Alaska Railroad Corporation
327 W. Ship Creek Ave.
Anchorage, AK 99501

Addendum 2

ITB #23-62-211309

Seward Coal Dock –Loading Equipment Demolition

PIER TYPICAL SECTION

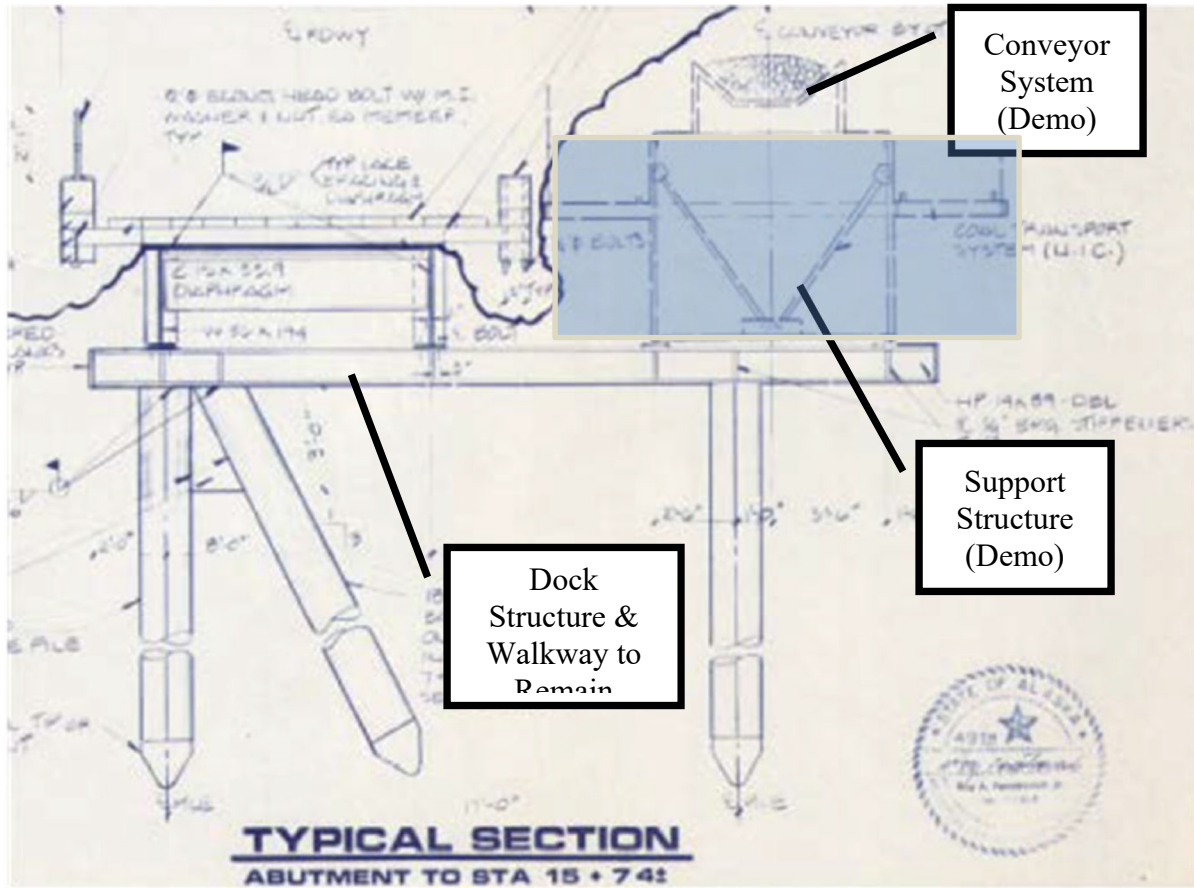
It would be helpful to add notes or demolition call-outs to the “Pier Typical Section” provided on page 17 of 98 of the ITB.

Also, please verify the scope of this bid item includes “BC-14” only (as shown on page 5 of the “Seward Coal Facility Valuation Report”).

The Limits of proposed demolition are for BC-14 as shown below. The On-Shore segment shown in yellow is to be bid as Additive Alternate A2
